## PRELIMINARY PLAT REVIEW PUBLIC HEARING

**FOR:** Osprey Landing Subdivision  
**WHERE:** Hwy 33 W 3000 S  
**PREPARED FOR:** Board of County Commissioners  
Public Hearing on April 28, 2025

**APPLICANT & OWNER:** Bidache, Inc., represented by Sadek Darwiche  
**ENGINEER/SURVEYOR:** Y2 Consultants, Megan Nelms

**OVERVIEW:** Applicant is proposing a 12 lot subdivision on 30 acres on Hwy 33 and W 3000 S. Proposed lots are all 2.5 acres. A fire pond is proposed on Lots 3 and 4 of the development. Each lot is proposed to have individual well and septic systems. Parcel is within the regulatory floodplain and scenic corridor overlays.

Figure 4. Preliminary Plat

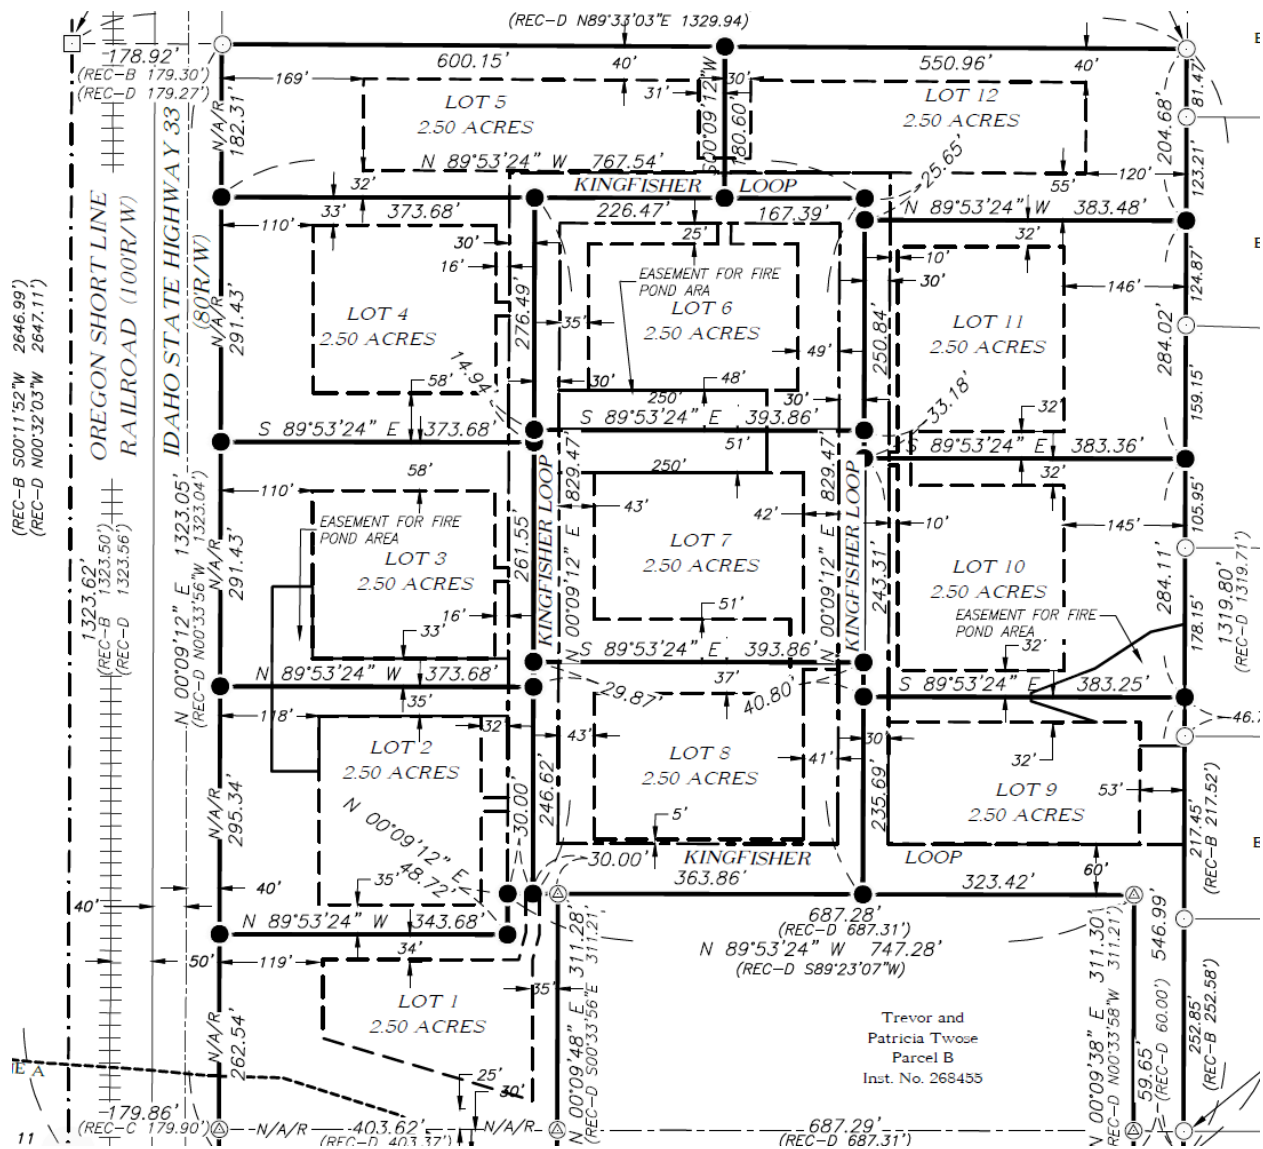
1. The plat should be updated in the following ways:
  1. Signature for Planning & Zoning is the Chair person.

2. Plat should include the proposed building envelopes from the improvements plans –
3. A plat note indicating that all lots will be accessed from the interior subdivision road.

4. A plat note be added referencing the flood plain.
2. An approved access permit for the subdivision road off of W 3000 S should be submitted with the final plat application.

*Staff comment: The applicant has amended the preliminary plat signatures and notes. Applicant submitted revised CCRs and improvement plans that incorporated the landscaping and proposed berm. Applicant also revised the NRA to incorporate floodplain data.*

Figure 5. Updated Preliminary plat

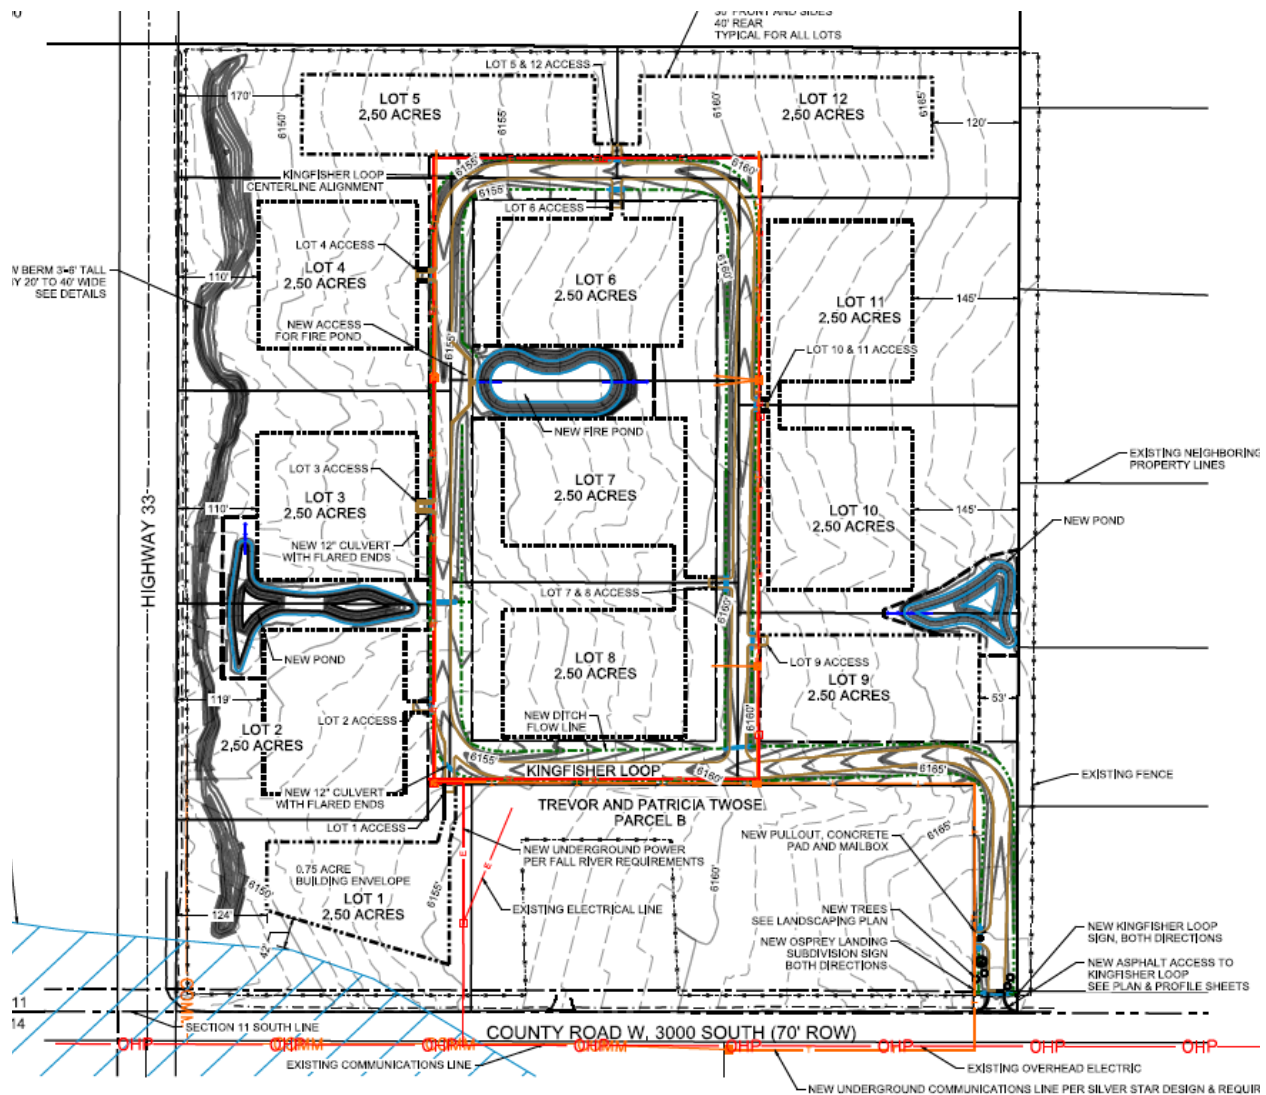
1. The plat should be updated in the following ways:
  1. A plat note indicating that all lots will be accessed from the interior subdivision road.
2. An approved access permit for the subdivision road off of W 3000 S should be submitted with the final plat application.

5. Applicant submit proportionate share amount of turn lanes as a lump sum with the development agreement.
6. Establish the base flood elevation for the project site and ensure that the proposal including building envelopes and location of proposed berms conforms with requirements of Title 12 V.A.3 &4.
